Optimization Review Report Remedial Process Optimization Study

**Olin Corporation (McIntosh Plant)
Operable Unit 1
McIntosh, Washington County, Alabama
EPA Region 4**

FINAL REPORT
January 2020

Figure 3: Olin Site Groundwater Elevation Map [Excerpted from the Annual Effectiveness Report (AECOM, 2018); all figures are reproduced at full size in Appendix B]

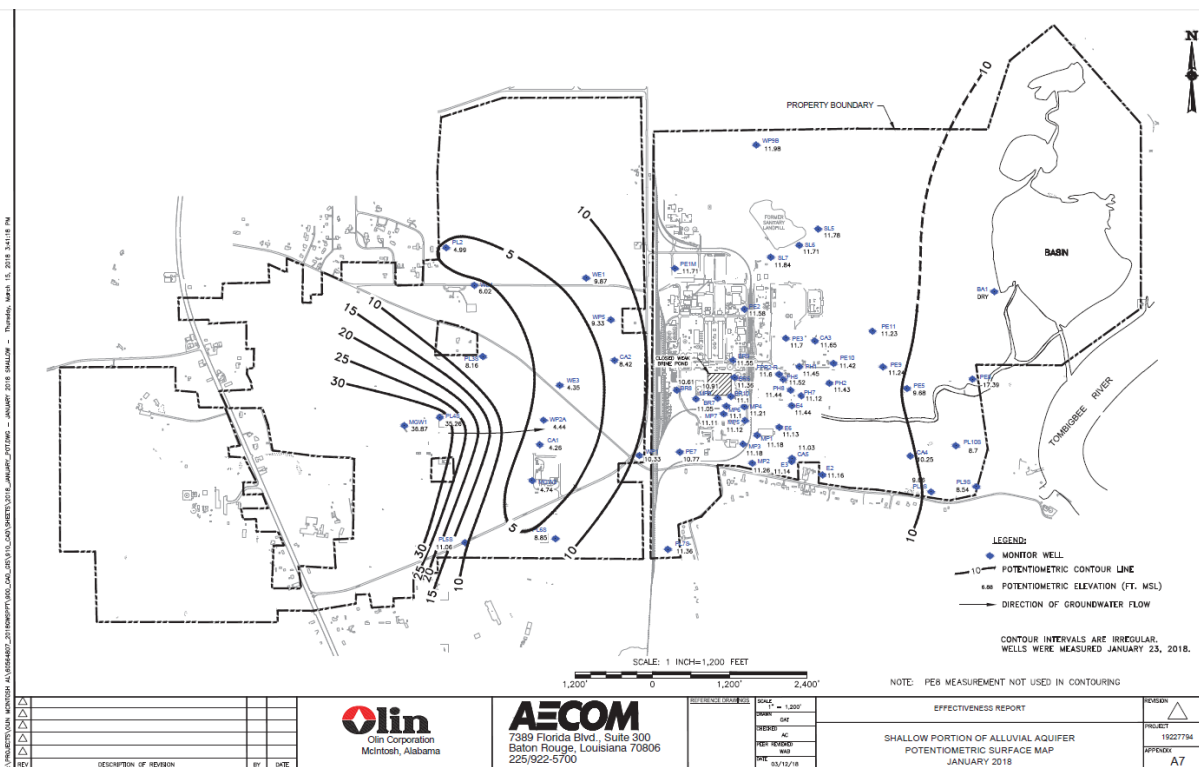
The alluvial aquifer is unconfined with relatively flat gradients across the plant in the absence of pumping. Potentiometric surfaces measured in the alluvial aquifer (Figure 3) indicate a groundwater divide running north to south in roughly the same area as the surface water divide. Groundwater in the western part of the plant area flows west. Groundwater east of the main industrial plant flows east/southeast and discharges to the Tombigbee River during low river stage (gaining) and reverses (losing stream) during periods of high river water. A potentiometric low in the alluvial aquifer is observed west of the plant in the area of WP6A, WE3, and WP10. Farther west of the groundwater low, a higher water table is observed in the alluvial aquifer in the area of the brine wells. There is a steep hydraulic gradient with a high near well MGW1 and the low near WE3.

The effect of the shutdown of the P&T system has been to flatten the groundwater gradient in the developed area of the plant, but there is still a flow divide with groundwater east of the railroad tracks flowing toward the Tombigbee River and groundwater west of the railroad tracks flowing toward a local potentiometric low near wells WP10 and WE3. Drawdown resulting from operation of the CA wells also masked the groundwater low west of the plant, which did not become readily apparent until water levels were measured in the absence of CA well operation.

Figure 4: Olin Site Cross Section [Excerpted from the *Corrective Action Review and Recommendations for Operable Unit 1* (Amec, 2014); all figures are reproduced at full size in Appendix B]

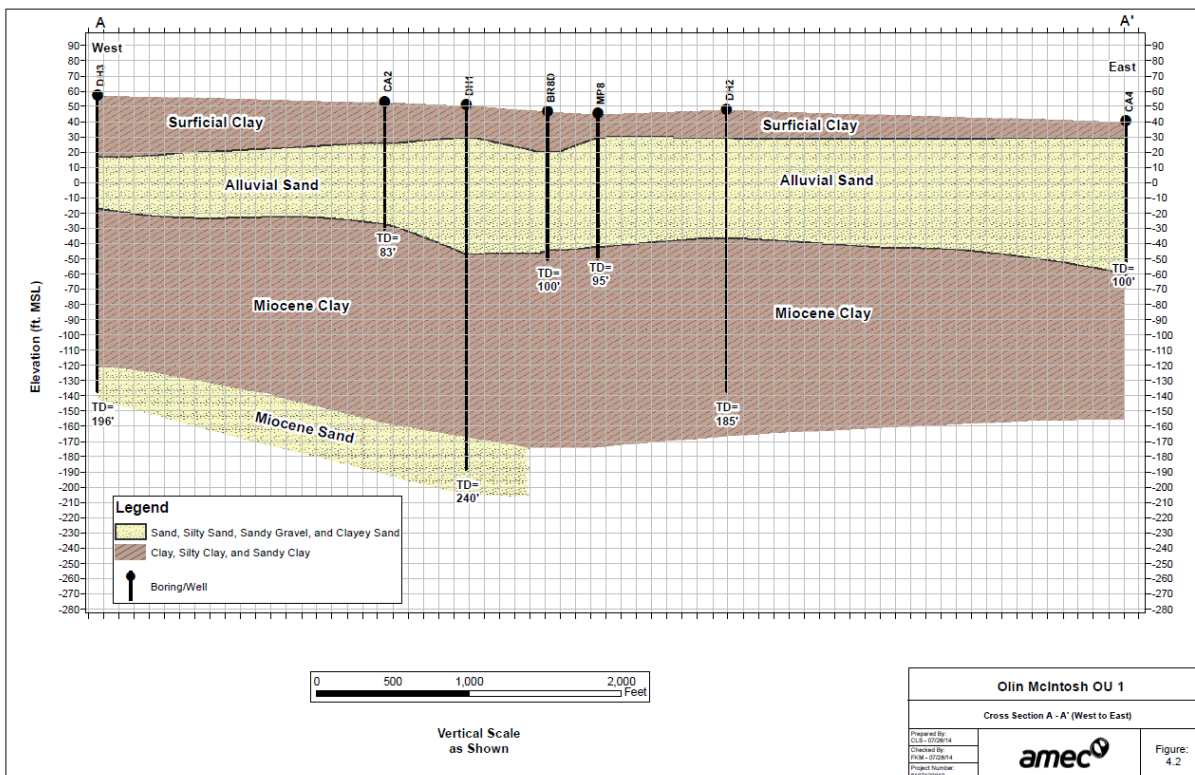
Most boring logs from the Site indicate that the Miocene clay is a substantial barrier to downward flow. However, a cross section in the area the former evaporator (near borings DB-13 and P-34 [see Appendix B]) show a sandy channel in the Miocene clay. There are insufficient data from the western part of the Site to determine if the Miocene clay is thin or if there are sand channels present in the area of the potentiometric low.

The Optimization Report recommended the installation of a Miocene monitoring well near the area of low groundwater elevations west of the industrial area. Boring logs for DH1 and DH3 show that the Miocene confining unit is intact and approximately 100 feet thick west of the plant. DH1 and DH3 are approximately 1,500 feet from the groundwater low west of the industrial area and located east and north of the area, respectively. The layout of these two data points makes it improbable that the confining unit is not present in this area of low groundwater elevations. As noted in Section 4.2.4 (page 18) of the Optimization Report, impacts to groundwater in the Miocene would likely be low and captured by Olin's production wells located northeast of the manufacturing area. Constituent migration would also be observed by ongoing monitoring at DH1 which is downgradient from the groundwater low area in the Miocene aquifer. Results from DH1 and DH3 show that constituent concentrations are below groundwater protection standards. The installation of an additional Miocene well is not expected to provide additional information beyond what is already known for the Miocene. A new well would provide redundant information and is not necessary.

Figure 5: Suggested Sampling Transects. [Base map from the Annual Effectiveness Report (AECOM, 2018)]

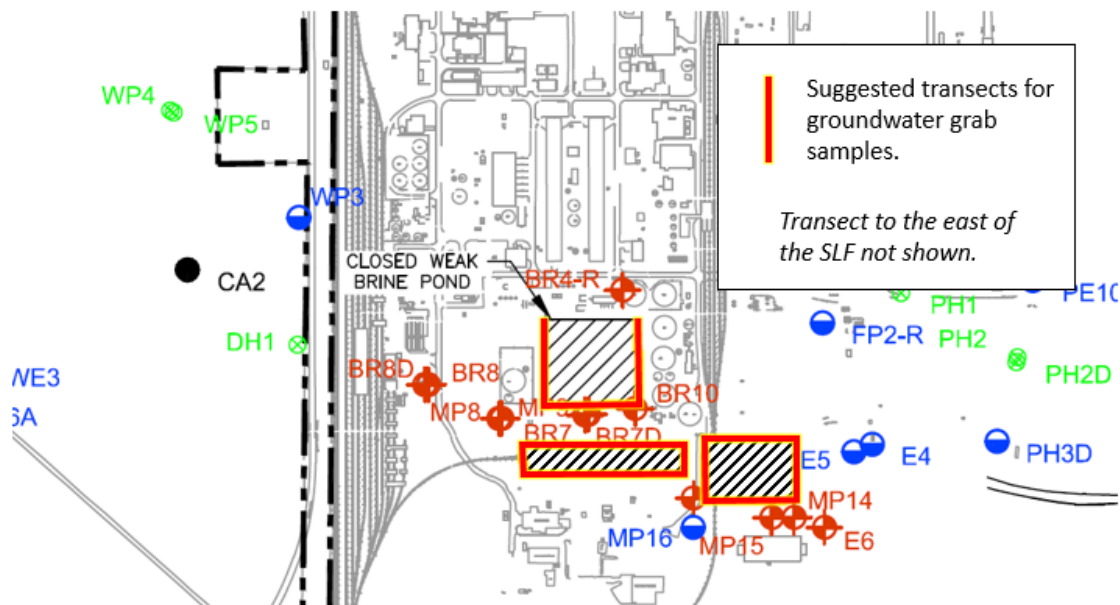
This remedial approach focuses on source remediation, recognizing that the existing low-level plumes will attenuate over time once the sources are addressed. The initial step will be to identify and characterize the remaining sources. Direct-push should be used to collect ground water grab samples in the vicinity of the Weak Brine Pond, CPC Plant and Landfill, and SLF. If direct-push is not capable of advancing through the surficial clay, then an alternate technique will be needed. Mini-sonic with push-ahead sampling can potentially be used. Alternatively, a drilling technique (hollow stem auger, mud rotary, or sonic) could be used to penetrate and case off the shallow clay; direct-push could be used for sampling within the alluvial aquifer.

The grab samples would be collected in transects and at multiple depth intervals to try to target the location and depth of remaining sources. Once the areas of the locally elevated concentrations are identified, vadose zone soil sampling can be conducted if appropriate. Figure 5 outlines the optimization team's suggestions for the transect locations near the Weak Brine Pond and CPC area, with 50-ft

horizontal spacing between sampling locations within a transect. A transect to the east of the SLF is also recommended. Note that the figure does not include any characterization around the former Mercury Cell Plant because the optimization team understands that this area is not accessible for intrusive work due to ongoing facility operations. If a source is present, it will become apparent with concentration trends at WP3 or other monitoring locations once the other sources have been addressed. The optimization team cannot offer source remediation options for this location given that it is inaccessible for intrusive work.
